Access Compliance Report

Public Rights-of-Way

(Curb Ramps)

Intersection ID: 6215	Main Street: IRISH_MOSS_LN	Cross Street: ALLEN_RD_SOUTH	Location: NE
ADA ID: 4C56D53E7A8A	Ramp Type: Directional1	Initial Pass/Fail: Fail	Overall Compliance: No
		Severity Score: 35

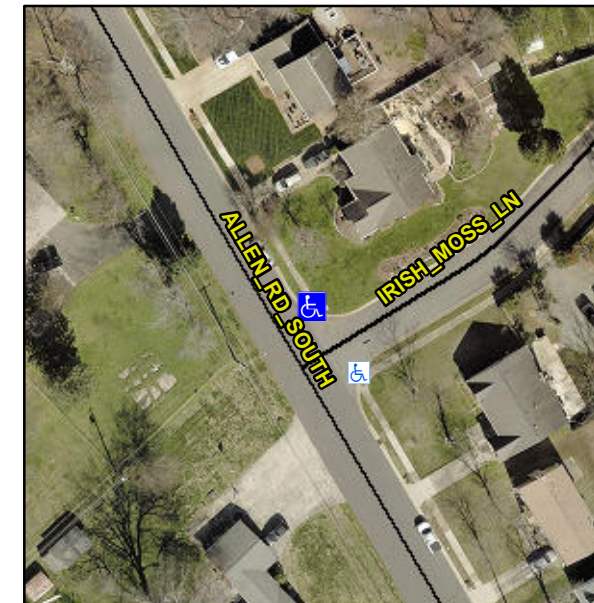
Surveyor Notes:

DWS DETACHED

PROW/ADA:

R304.5.1, R304.2.2, R304.5.3

Possible Solutions:

Remove & Replace Entire Ramp.
